DEVIATION REQUEST (Attach diagrams, figures, and other documentation to clarify request)

A deviation from the standards of or in Section **2.2.5.C.** of the Engineering Criteria Manual (ECM) is requested.

CONSTITUTION STORAGE DEVELOPMENT

*PCD Filing No.: PPR-2224,
P-225*

SITE PLAN

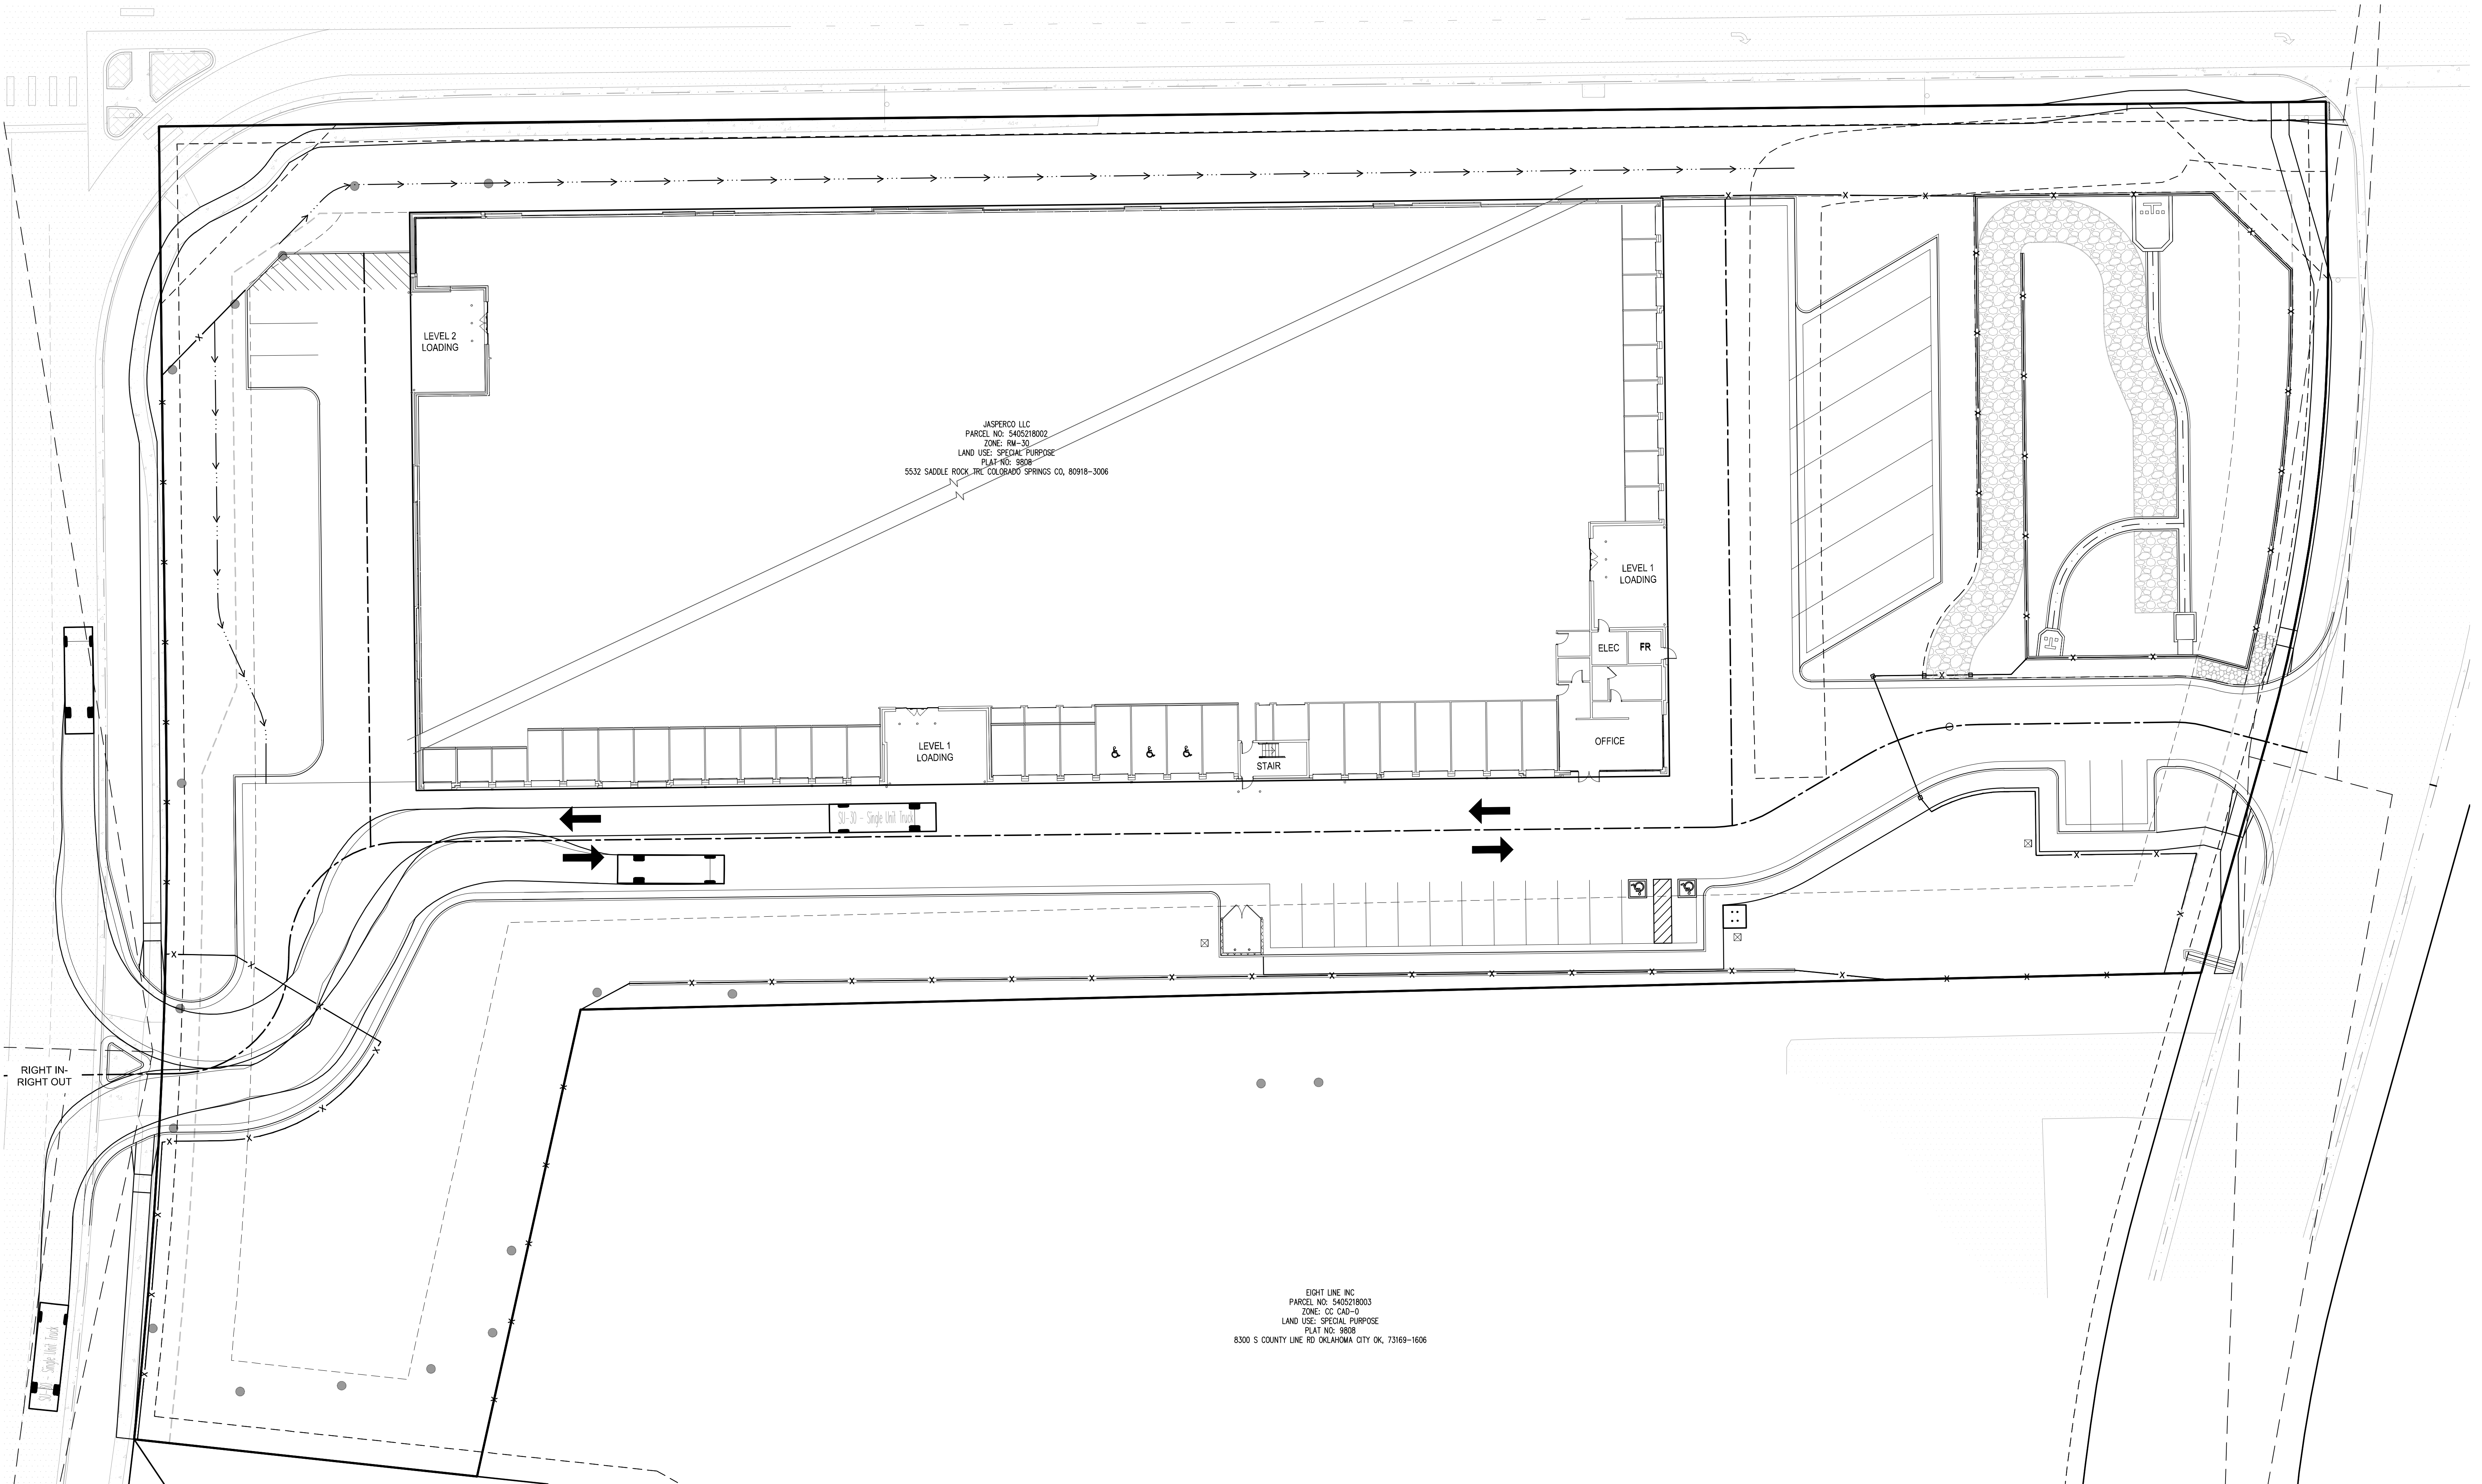
At this time no hardship has been identified if this access is not approved. Adequate justification has not been presented. Additional left turns to exit the site does not inhibit the approved access location. The site can be designed to accommodate the allowable location of the proposed access.

Given the classification and the amount of traffic on Peterson we cannot recommend access at this location.

No justification was provided to suggest that a criteria change is required or needed.
